**ITEM #1 - PRELIMINARY PLAT
L. CREARY SUBDIVISION LAUVER ADDITION**

KPB File No.	2026-047
Plat Committee Meeting:	June 8, 2026
Applicant / Owner:	Lani & Kevin Lauver / Soldotna
Surveyor:	Jason Young / Edge Survey and Design, LLC
General Location:	Echo Lake Rd

STAFF REPORT

L. CREARY SUBDIVISION LAUVER ADDITION

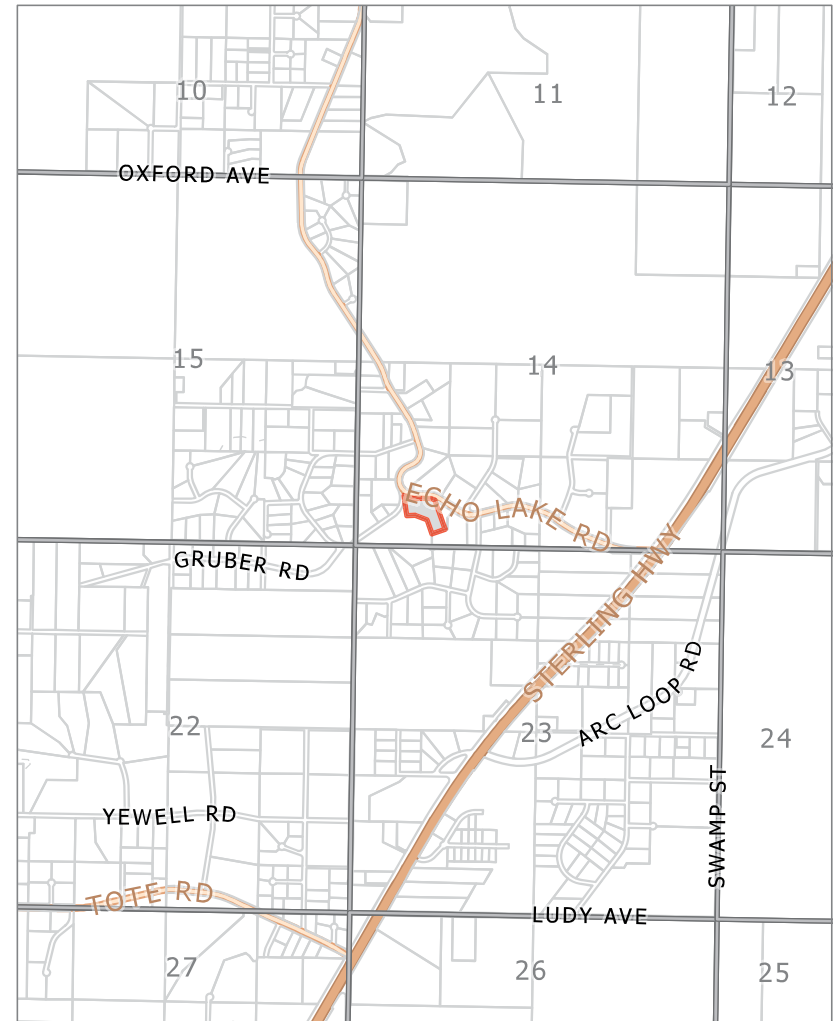
The parent plat also notes a 20' wide easement covering the overhead power line. The easement is noted but not shown on the drawing and should be added.

Text from the section line up to the plat has overstrikes on it, please correct.

Correct (R6) reference to 81-39.

All bearing on the north line of length 252.50' should be S##-##-##E or N##-##-##W, please adjust.

Plat note 7 CCR in Bk 128 Pg 659 and Bk 153 Pg 238 do not affect this plat, note can be removed.

Plat Note 8 can also be removed with no CCR to be addressed.

Modify KPB File No. to 2026-047

Add a space of L. and before Creary in the Plat name and the legal description, make L. Creary.

- o Modify Echo Lake Road label to "100' ROW" as dedicated by KN 1598
- o Confirm 60' roadway easement source adjacent to west boundary of proposed lot 4A. Appears to have been dedicated by KN 1407?
- o Correct spelling of Gruber Rd to the west.

- Provide labels for Echo Lake, Ashana Lake, and Arc Lake
 - Slikok Creek appears to flow through sections 23 and 26. Please verify and modify depiction.

- Correct the minor typo “Gruber Road.”
- E. All parcels of land including those intended for private ownership and those to be dedicated for public use or reserved in the deeds for the use of all property owners in the proposed subdivision, together with the purposes, conditions, or limitations of reservations that could affect the subdivision;
Staff recommendation:

- Verify location of OHP easement as noted in plat note 11 and referenced in parent plat as noted in HEA comment.
- G. The status of adjacent lands within 100 feet of the proposed subdivision boundary or the land status across from any dedicated rights-of-way that adjoin the propose subdivision boundary, including names of subdivisions, lot lines, block numbers, lot numbers, rights-of-way; or an indication that the adjacent land is not subdivided;
Staff recommendation:

- Modify Echo Lake Road label to “100’ ROW” as dedicated by KN 1598
 - Confirm 60’ roadway easement source adjacent to west boundary of proposed lot 4A. Dedicated by KN 1407?
